# WLTP

## PEV Range test procedure : End of test criteria

1. Present situation in GTR draft
2. Problem with Light commercial vehicle
3. Possible solutions
4. Proposal from ACEA

## 2 Problem with Light commercial vehicle : Impact of '4 second' end of test criteria

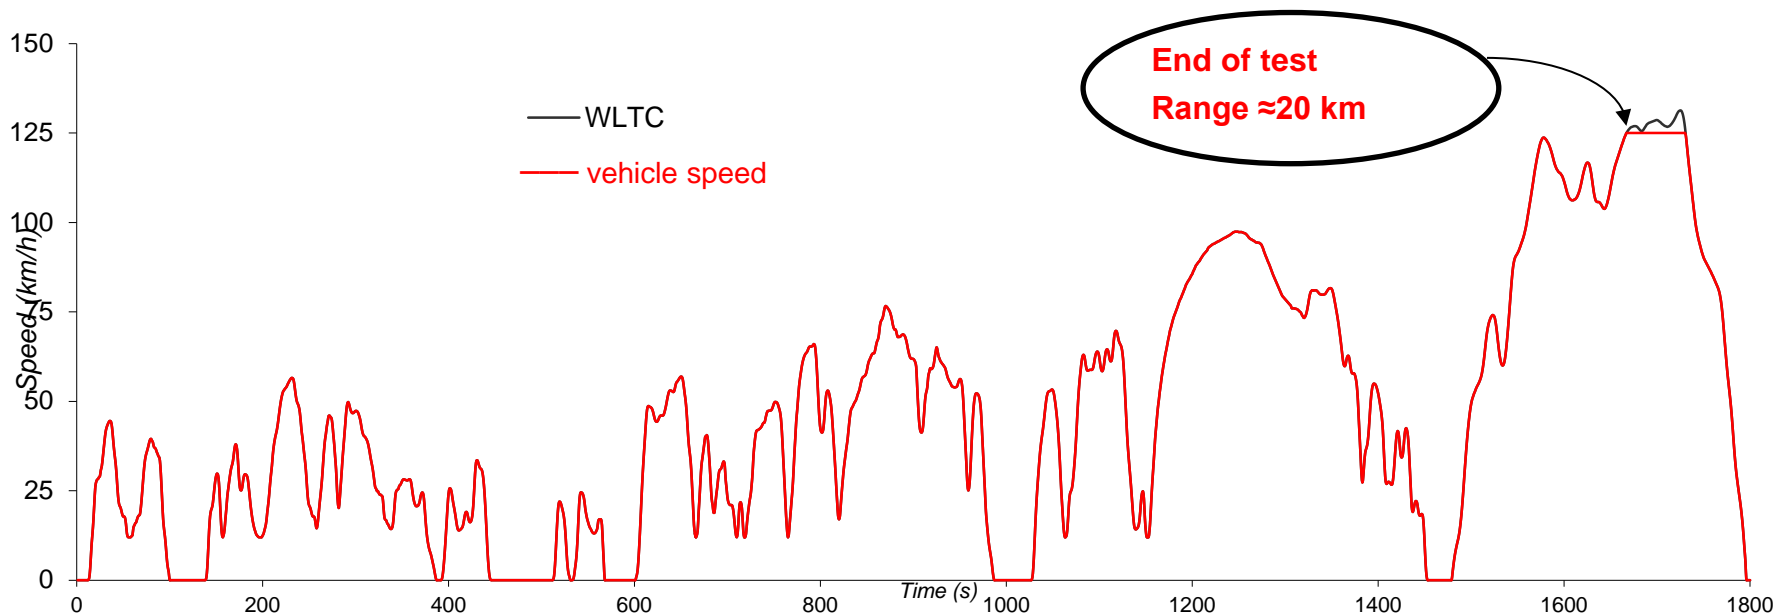
- *Pure electric vehicles are penalized compared to conventional vehicles (see slide 5)*
- *Most of 'Light Commercial Electric Vehicles' will be impacted by this criteria. These kind of vehicles are meant for urban but also for 'suburban' use (mostly limited to 110 km/h).*
- *Repeatability of electric energy consumption is not verified during the 'validation phase 2' for such kind of vehicle (not able to follow the drive cycle)*
- *Example of a vehicle with a maximum speed of 125 km/h will have a range  $\approx 20$  km*
- *Need to find a technology neutral solution for this issue*

### add the following text in addition to 3.4.4.3.1.3. to annex 8

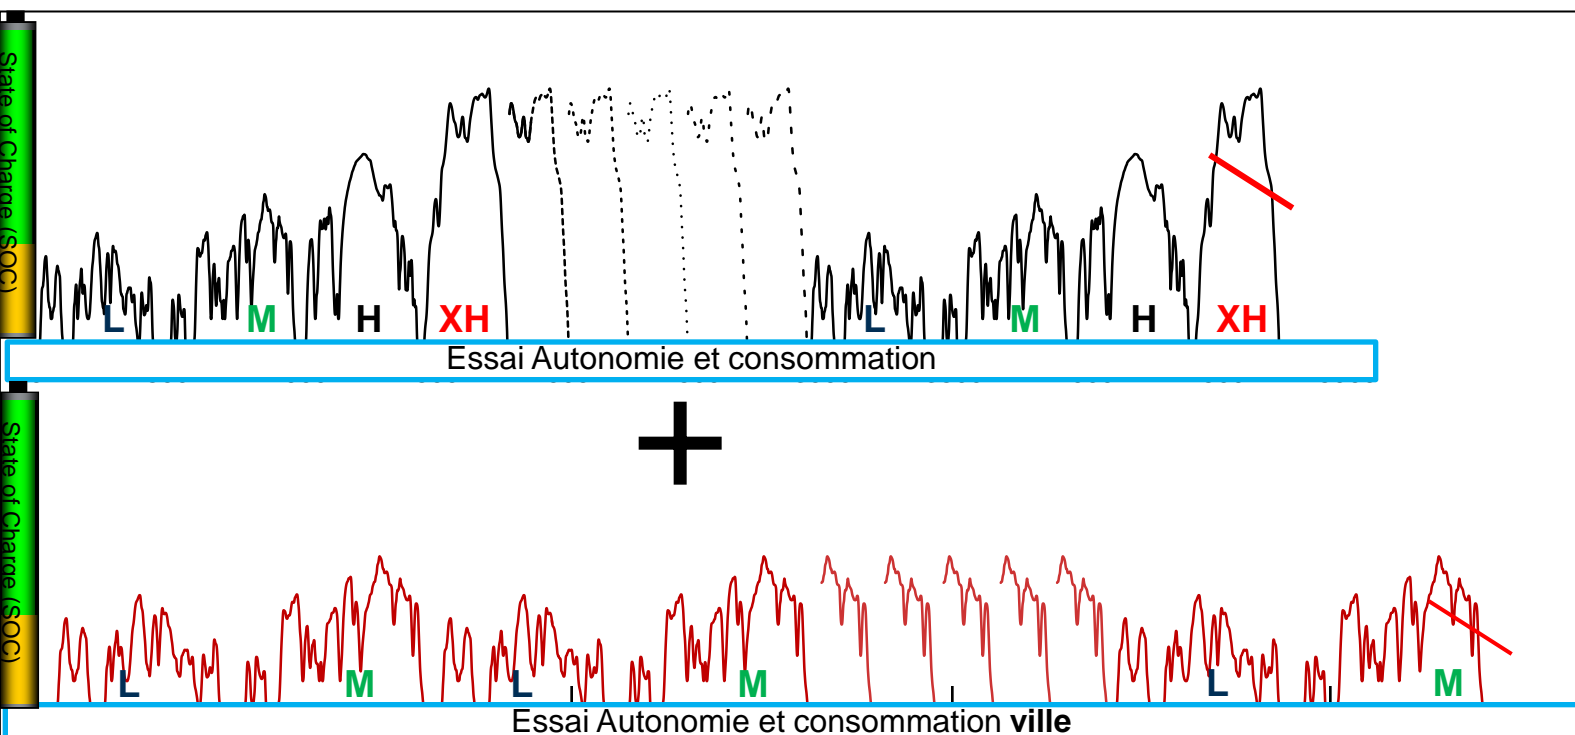
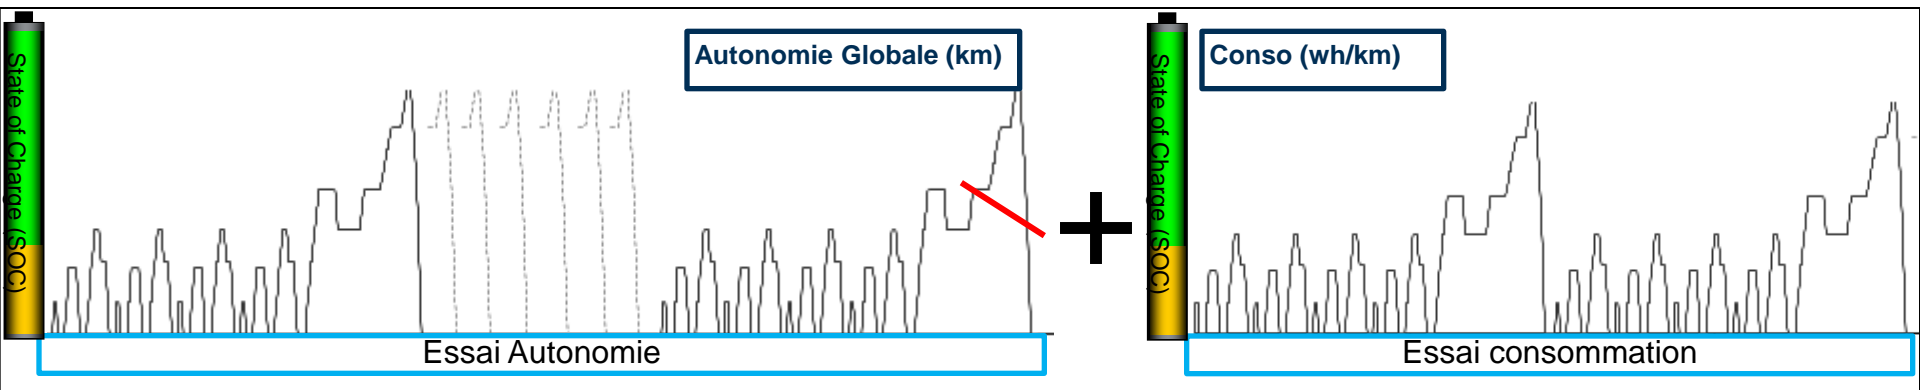
=> This criteria is agreed by ACEA members. This solves the problem of low speed vehicle better than the above two solutions.

- For vehicles that are not capable of meeting the prescribed speed vs. time relationship of the applicable WLTC drive cycle for the initial drive cycle (i.e., the first drive cycle that begins with the vehicle fully-charged) and operated at maximum available power, the test terminates when the following criterion is satisfied: 1) when the vehicle, while operated at maximum available power or “full throttle”, is unable to reproduce the best-effort speed vs. time relationship established by the vehicle in the first WLTC drive cycle of the test. The applicable drive tolerances for the best-effort trace are provided given in Section 1.2.6.6. of Annex 6 (+/- 2 km/h, +/- 1 sec).
- Note: The speed tolerance violation criteria given in Section 1.2.6.6. of Annex 6 do not apply to the best-effort trace for low-power vehicles
